**Proposed Category Map Amendments: Montgomery County Comprehensive Water Supply and Sewerage Systems Plan – Three Water/Sewer Service Category Change Requests – April 2020 County Council Cases**

Montgomery County Comprehensive Water Supply and Sewerage Systems Plan – Three Water/Sewer Category Change Requests

**COMPREHENSIVE WATER SUPPLY AND SEWERAGE SYSTEMS PLAN AMENDMENTS**  
**County Executive's April 2020 Transmittal Packet**  
**FY 2019 Category Change Requests**

**WSSCR 19-TRV-10A (Benjamin Gompf & Renee Shuman): Private Sewer Extension**  
**Sewer Service Area Category Change Request: Comprehensive Water & Sewer Plan Map**

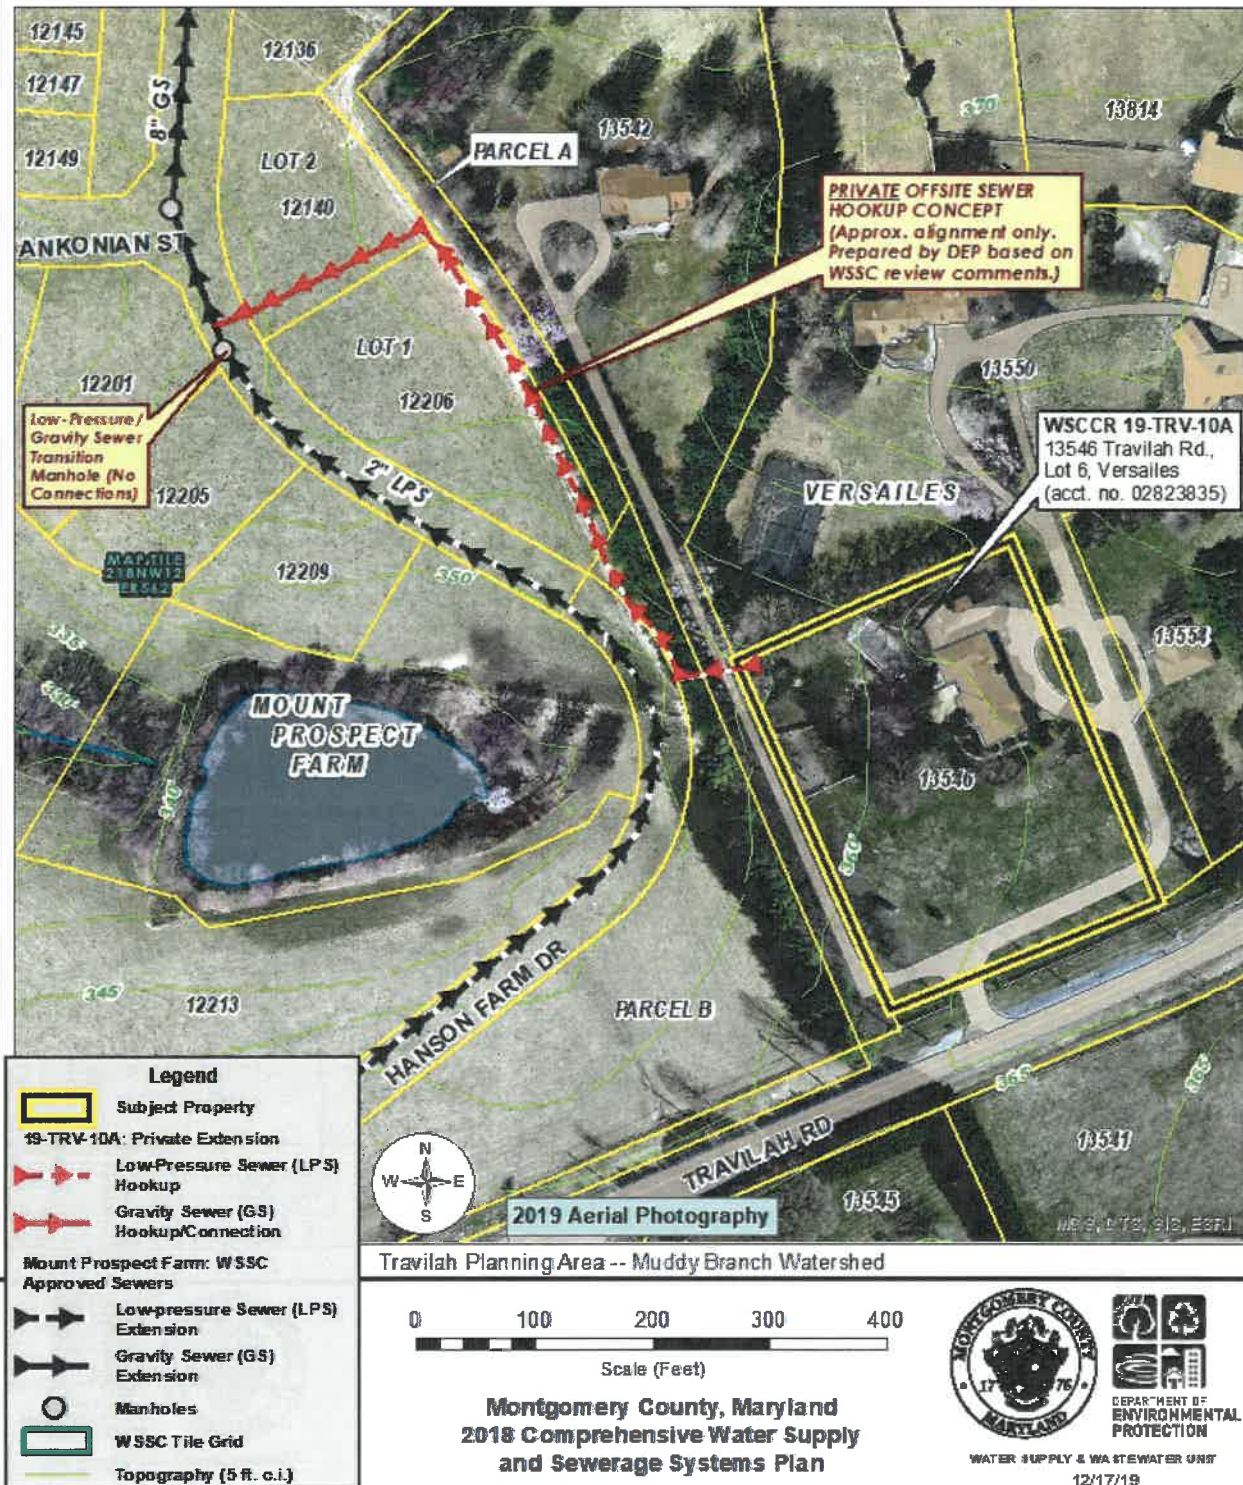
The applicants seek a category change for sewer service for the existing home at this location and to expand an existing childcare use. This two-acre property is in the RE-2 Zone and is located in the Travilah Planning Area, part of the Potomac Subregion. The 2002 Potomac Subregion Master Plan excluded this property, and the others around the intersection of Travilah and Dufief Mill Roads, from the plan's sewer envelope. It should also be noted that immediately adjacent lots in the Mount Prospect Farm community were explicitly configured for compatibility with the lower density and larger lots in the subject property's neighborhood and across Travilah Road. In addition, any sewer connection would have to cross homeowner's association land to reach Hanson Farm Drive. See page 24 of Attachment A.

property, and the others around the intersection of Travilah and Dufief Mill roads, from the plan's sewer envelope. It should also be noted that immediately adjacent lots in the Mount Prospect Farm community were explicitly configured for compatibility with larger lots in the subject property's neighborhood and across Travilah Road. In addition, any sewer connection would have to cross homeowners association land to reach Hanson Farm Drive.
